### Product Line: ATV

Bulletin No: 2004-2-02

Subject: Oil Drain Hole/Belly Panel

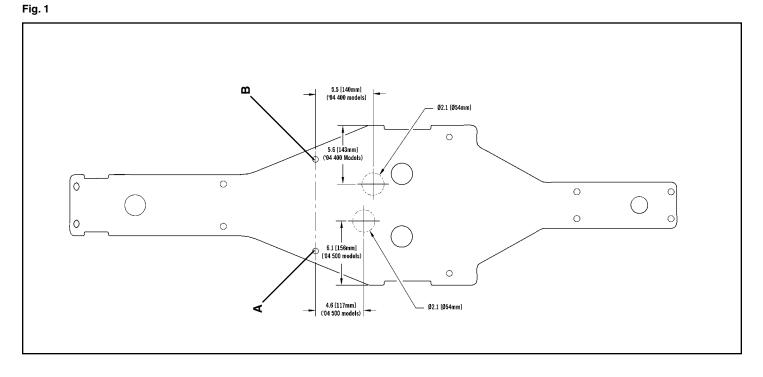
- **Condition:** It has been determined that an incorrect Belly Panel (p/n 1406-030) was installed on the affected models indicated above. Because of this condition, the oil drain hole in the belly panel does not align with the drain plug.
- **Solution:** On all affected ATV's, it will be necessary to drill a new oil drain hole in the belly panel. See the instructions included in this bulletin.
- **Parts:** Not Applicable (No Parts Needed).
- **Warranty:** A labor allowance of 0.2 hr will be paid per affected ATV. Cat Tracker Claim: Enter BA200402 in the Complaint section. Manual Claim: Enter 402A in the Complaint section.

- 1. Turn the gas tank shut-off valve to the OFF position; then secure the vent line to prevent gas from leaking. Place the ATV on its side.
- 2. Thoroughly clean and dry the belly panel area to be serviced.
- 3. Using the provided template as a guide, make a horizontal line through the center of belly panel plate holes "A" and "B". Making sure to use the appropriate measurements, make another horizontal line on the belly panel below and parallel with the first line. From the outside edge of the belly panel, measure inward as indicated in Fig. 1. Mark the center of the new oil drain hole on the belly panel.

- 4. Using a 2 in. hole saw, carefully drill out the new hole taking care not to drill into the engine case/drain plug.
- 5. Place the ATV in an upright position; then turn the gas tank shut-off valve to the ON position. Return the vent line to its original position.
